Return Loss Measurement Consensus Group Meetings Summary

Liav Ben-Artzi
Marvell Technology Group

Comment #166

Difference between two packages cannot be distinguished

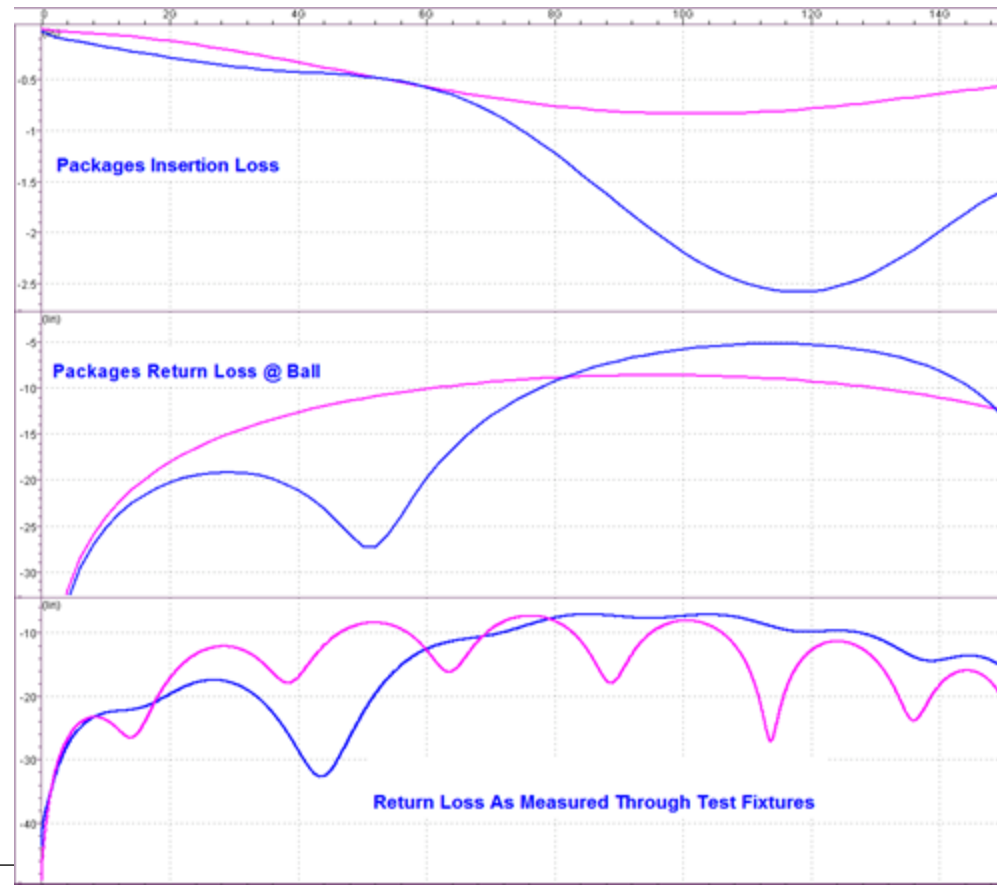
- It is extremely easy to demonstrate how two very different packages' behaviors measurements are masked by test fixture tolerance.
- May require chip over-design (to meet specific fixture RL) or allow qualifying a problematic chip RL if fixture is good enough...

Measuring through an interconnect as defined in 93.8.1.1 can obfuscate real chip return loss measurement.

Redefine fixture definition to improve the fixture quality by defining:

1. Better return loss (-15dB up to 13GHz)
2. Defining fixture ILD ($|ILD| < 1\text{dB}$)
3. Fixture IL up to 1.6dB

It is taken into account that fixture may not be feasible in multi lane device. In this case it is required that the actual fixture be "de-embedding worthy".

In this case the real fixture will be de-embedded and the defined fixture embedded.

Difference between two packages cannot be distinguished

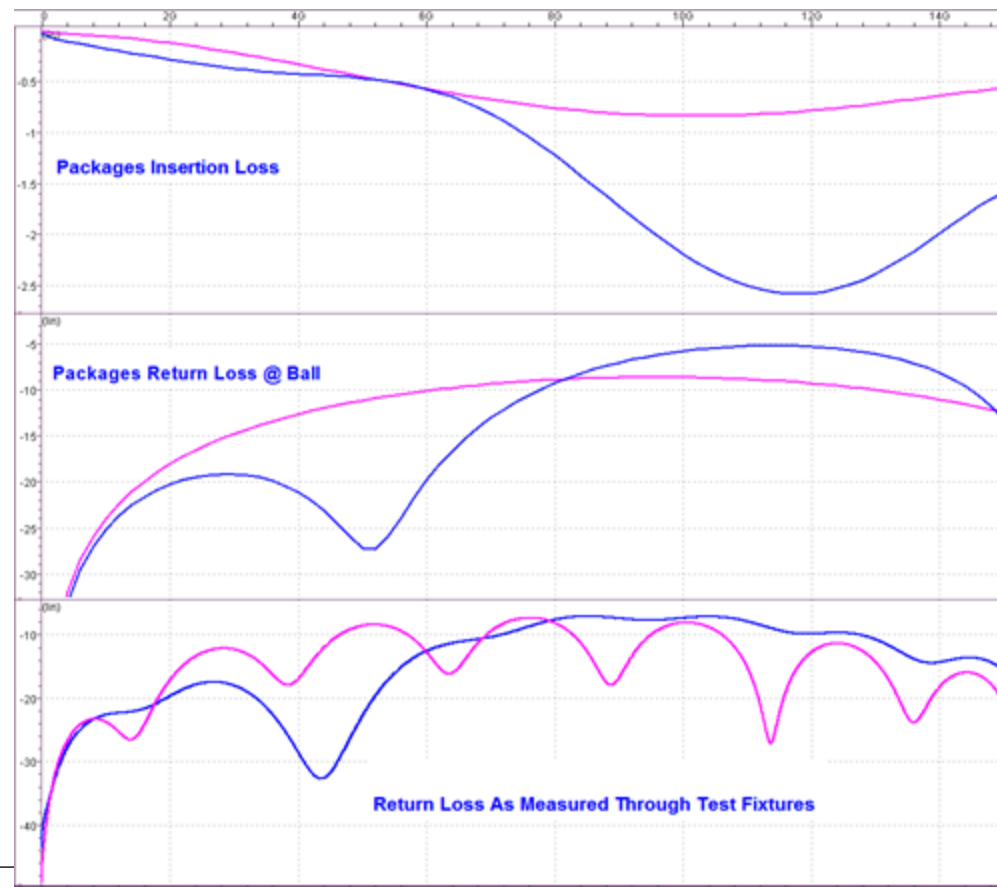
- It is extremely easy to demonstrate how two very different packages' behaviors measurements are masked by test fixture tolerance.
- May require chip over-design (to meet specific fixture RL) or allow qualifying a problematic chip RL if fixture is good enough...
